# **Quick Service Manual**

Ref. No.: HA-97-195

"Error" Indication in Disc Search

Mechanism jamming problem

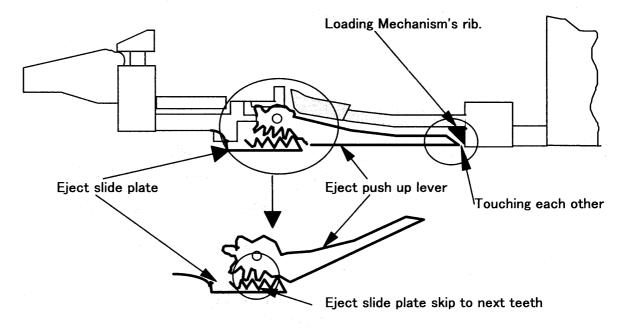
Traverse Loading Mechanism doesn't move at all.

According to our investigation result, This is for only one situation such as below.

- 1) When the Eject Lever was pressed, while eject Lever position was same number with play position ( example : 10 slot ), it will touch to Loading Mechanism's rib.
- 2) Then if the Eject Lever was pressed more strongly, The gear of Eject slide plate will be skip to next teeth.
- 3) Usualy the Eject side lever will be go back to initial position by spring, but in this case it doesn't go back to initial position for gear sticky. So Eject Lever will stay upper position.

As a result, Loading Mechanism movement is disturbed.

- 1) Change eject push up lever Ass'y from old type (RFKNLMC50PEK) to new type (RFKNCH64MP-K).
- 2) Change eject slide plate from old type (RML0439) to new type (RML0439-1)

## < Improvement Point >

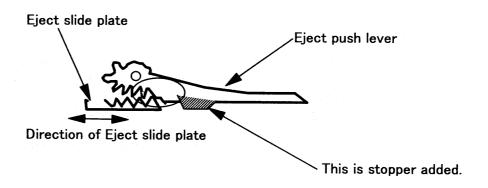
1) Eject push lever add material. ( change shape )

#### 2) Eject slide plate
